PART 21 REPORT - SWAGELOK U SERIES BELLOWS VALVES LOOSENING OF STEM TIPS

Date: April 17, 2012  
To: Document Control Desk  
Nuclear Regulatory Commission  
From: Bruce Flusche  
Part 21 Coordinator  
Swagelok Company  
Total  
Pages: 7 (including cover)  
Subject: Potential part 21 notification

**Subject: Potential 10CFR21 notification**

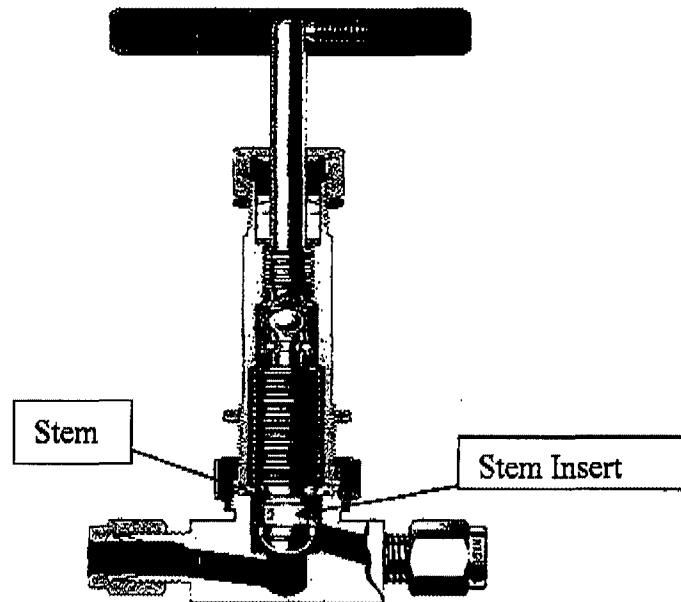
Swagelok received a return from Duke Energy for two 8U series bellows valves for investigation of stem tips that had loosened during performance testing of equipment.

Our evaluation confirmed loosening of the stem tips and determined the root cause to be higher than normal torque being applied to the valve handle during closure. *(Please note that we did not specify a minimum or maximum torque for our operating instructions.)* This caused the stem and the stem insert interface to loosen, but not fully disengage. Our tests show that closure to catalog specification of  $4.0 \times 10^{-9}$  atm. cc/sec of helium can still be achieved with this condition.

The picture above shows a cutaway version of a valve in question.

**Tolerance stack-ups between the stem and stem tip for the 8U Series valve**

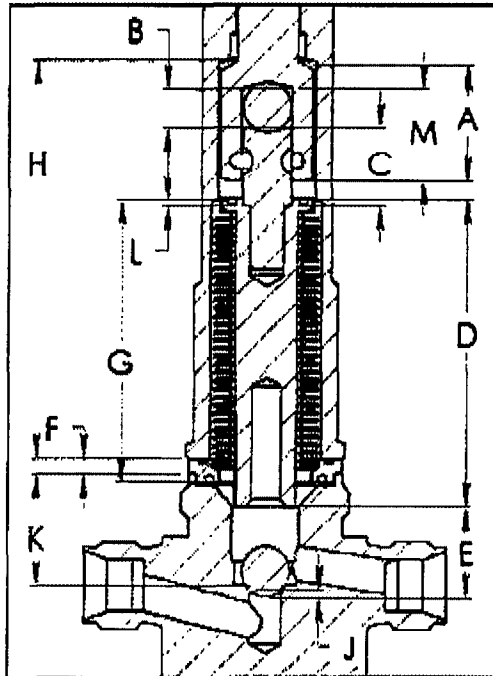
Although the stem tip may loosen when higher than normal torque is applied to close the valve, the tip will not become completely disengaged from the stem insert. The document below shows the stack up of tolerances on the 8U valve, with a loose stem tip. Even with the tip loosened until it contacts the valve body, at least one thread of engagement still remains between the tip and stem insert. This means the stem tip will remain captured within the valve body and will not enter the process stream. Similar conditions apply to the 4U and 6U Series valves.

<b>MAX STROKE</b>	<b>0.1755</b>
<b>NOM STROKE</b>	<b>0.1207</b>
<b>MIN STROKE</b>	<b>0.0959</b>

distance of stem adapter flat to top	0.270
distance of stem adapter flat to top- Max Stroke	0.0945
lead in to threads on stem adapter	0.026
threads per inch on adapter	24.0000
number of threads engaged at max stroke with loose stem (28E-29E*30E)	1.64

The continued engagement of the stem threads also means that the valve can be shut off, even if the threads had loosened. We have tested several conditions of the loose stem tips and confirmed that closure to catalog specification of  $4.0 \times 10^{-9}$  atm. cc/sec of helium can be achieved.

Revised drawings will be created for the affected utilities, showing both the recommended and maximum allowable closure torques, for the affected valve series.
